The following are the clarifications to the Plan Review Responses sent August 23, 2011. Revisions or clarifications have been identified with this written response.

Re:	PC #:	B1103915
	Commercial Plan Review Dated:	8.17.11
	Project Name:	Chase – CPC Alton
	Address:	1801 Alton Road
	Occupancy:	B

JPM Chase - Alton Road

CPC Interior Renovations

FLOOR PLAN - LIGHTING

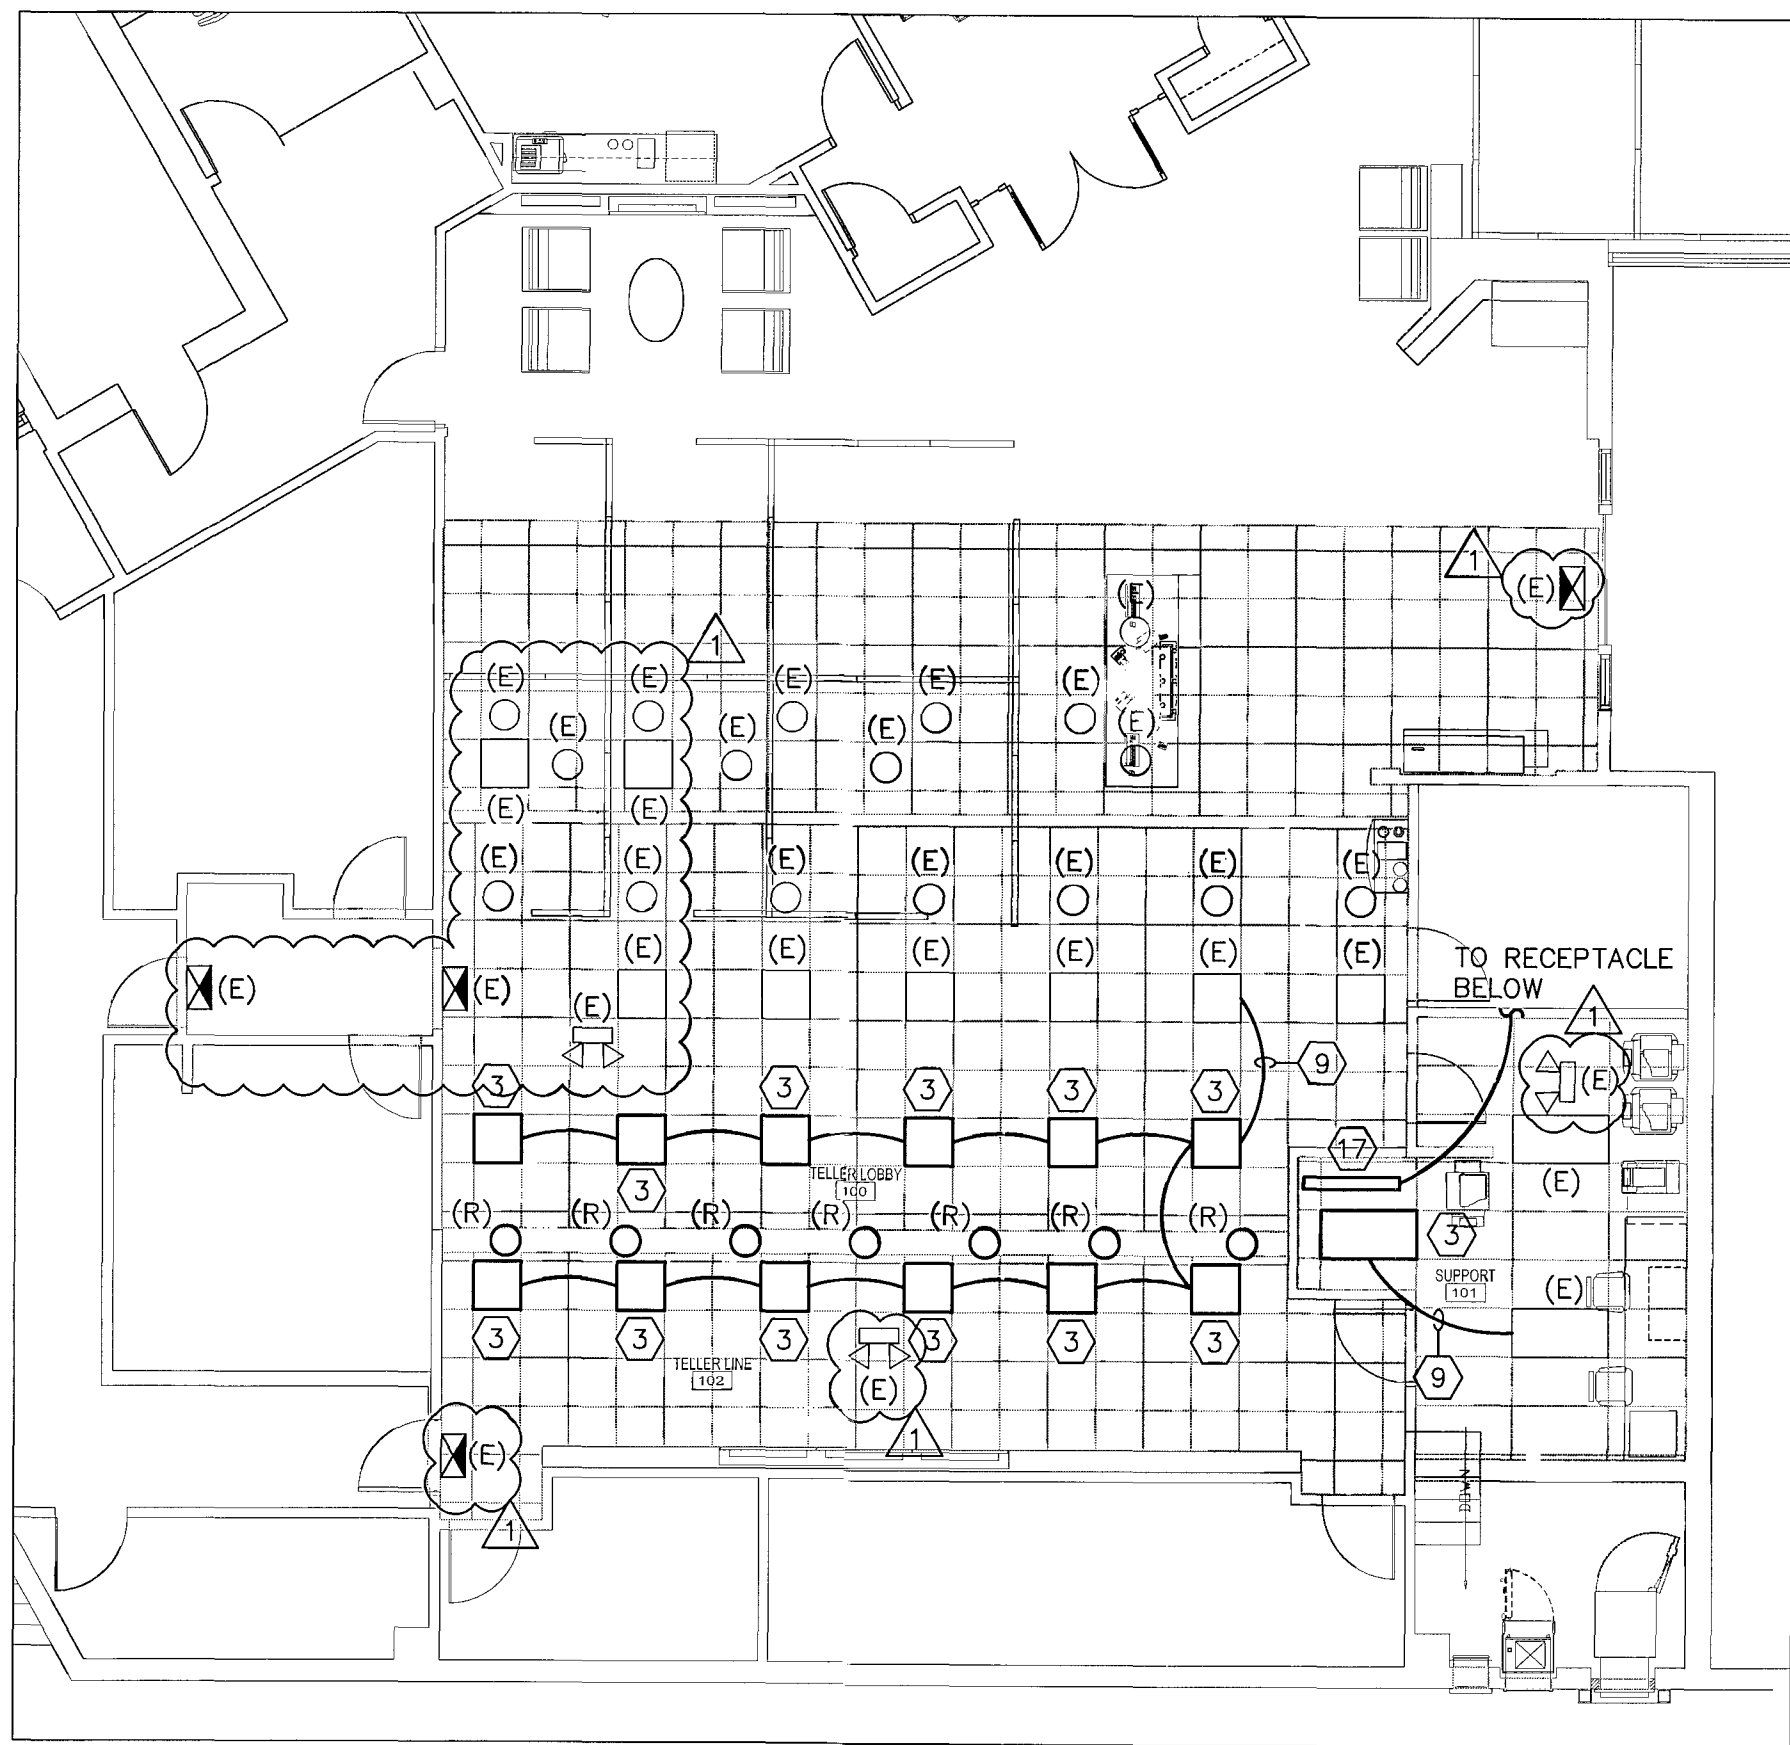
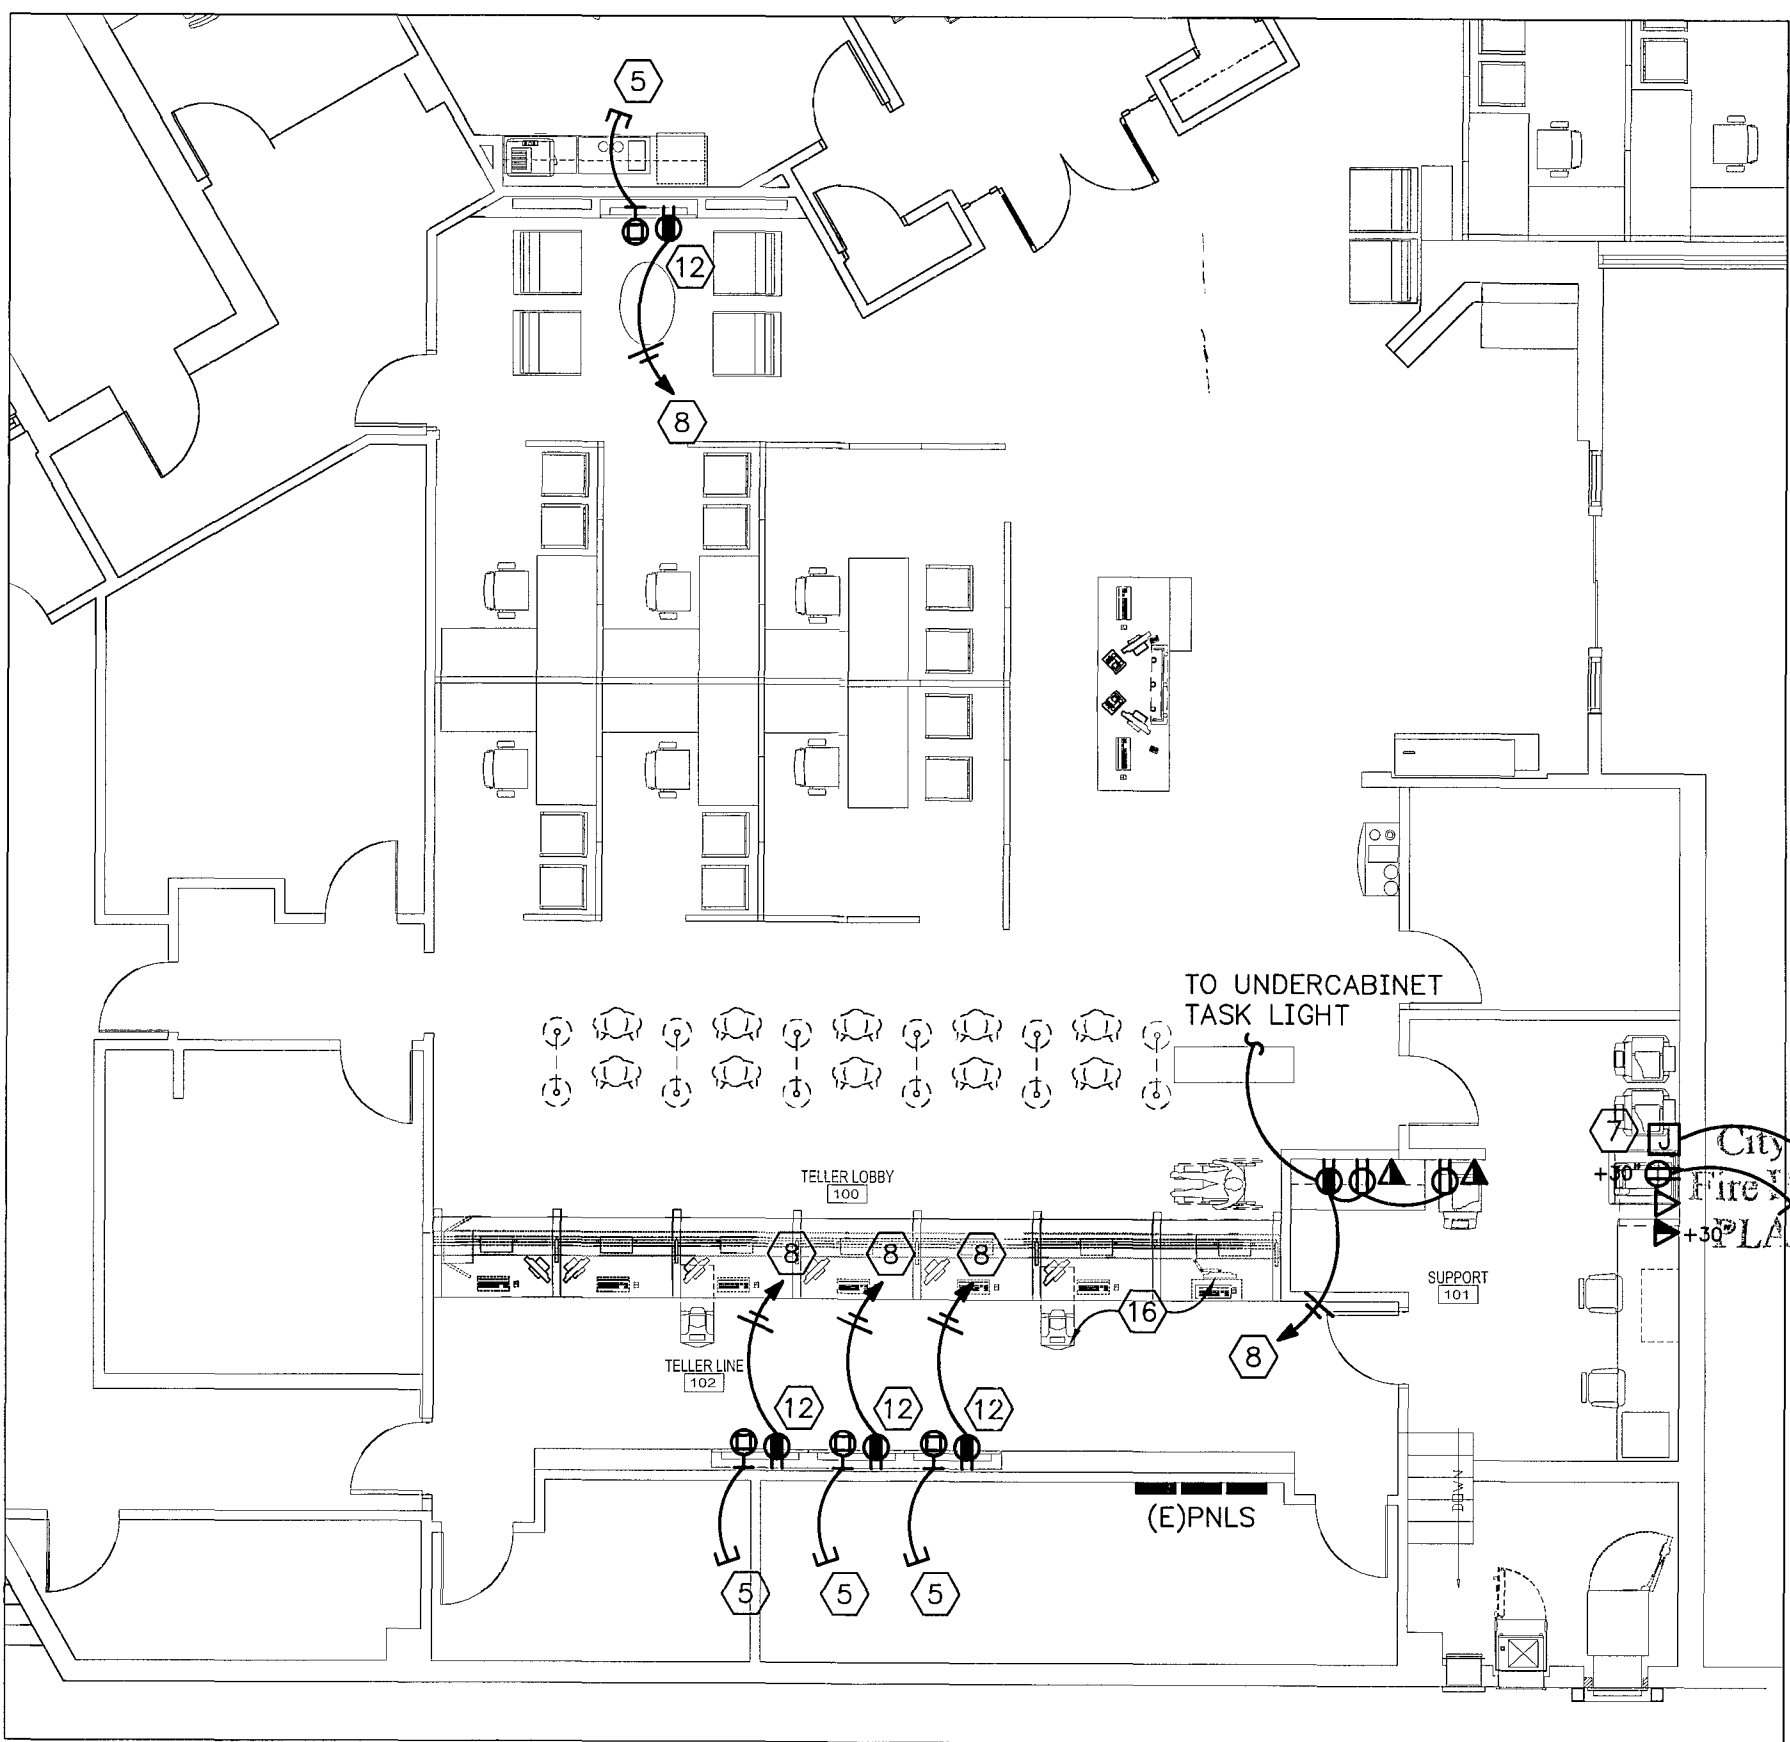
8. Label all areas sheet e100: 1. show location of emergency lights and exit signs, clarify if these items have battery backup rated for 90 min note once the architect/engineer answers the comments additional comments may follow.

RESPONSE: Please refer to the attached revised sheets A1.1 (reflected ceiling plan) and E100 for locations of emergency lights within the area of work. Areas have been labeled on sheet E100.
